Date: 2/5/08
To: All Contractors/Vendors
From: Linda M. Martin, Clerk
Subject: Addendum Number: 2
Project Name: Eddy Street Commons Phase II Parking Garage
Project Number: 108-004

ADDENDUM # 2

PROJECT: Eddy Street Commons Phase II Parking Garage
1200 Edison Road
South Bend, Indiana

**Addendum No. 2
February 8, 2008**

A-SK002

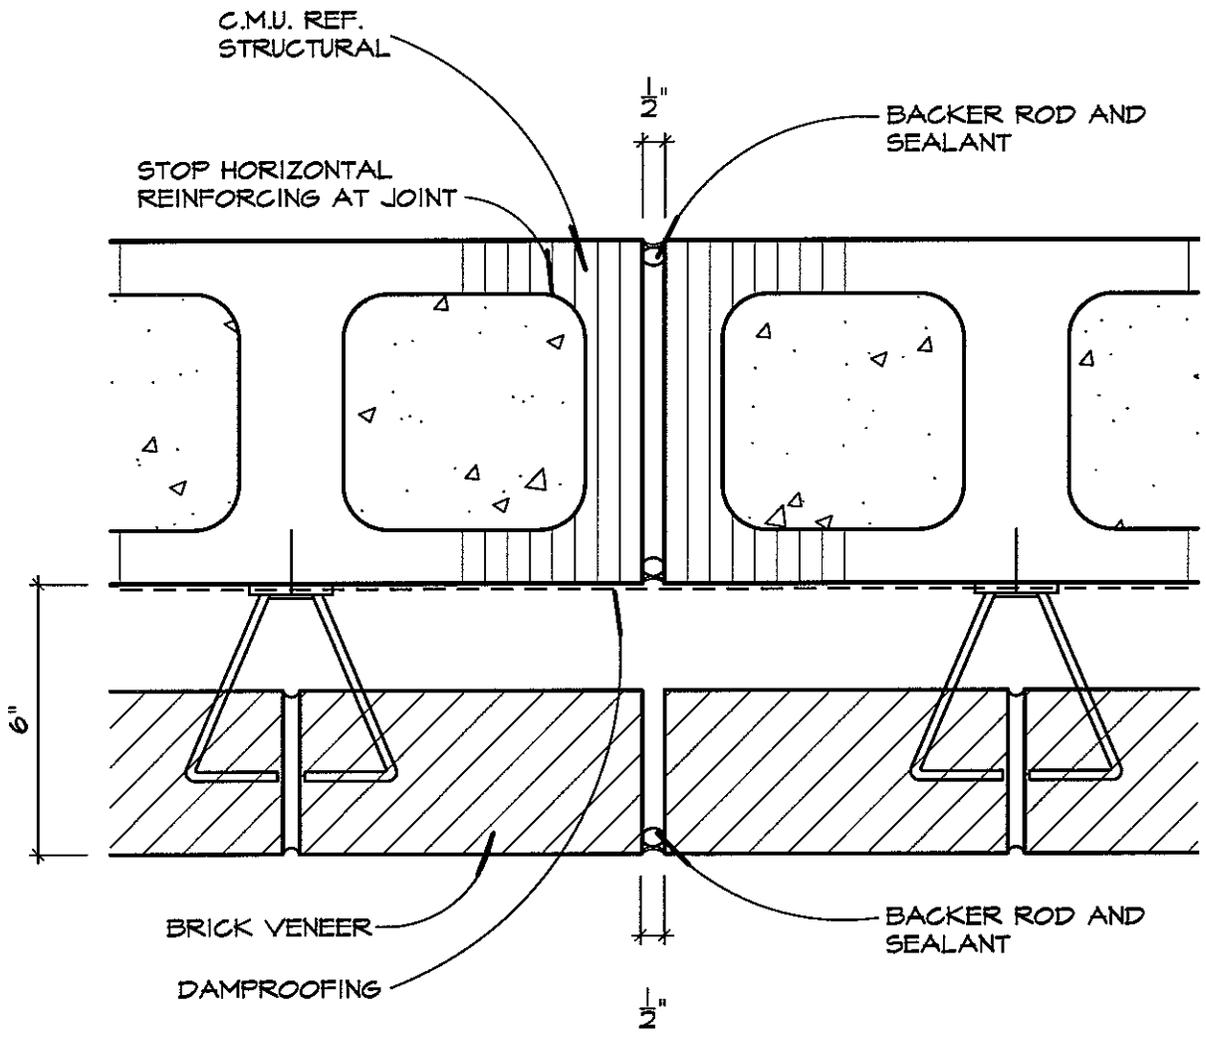
1. Delete Details 3, 4, and 5 in their entirety.
2. Insert attached Drawing A-SK001 as Detail 3.
3. Insert attached Drawing A-SK002 as Detail 4.
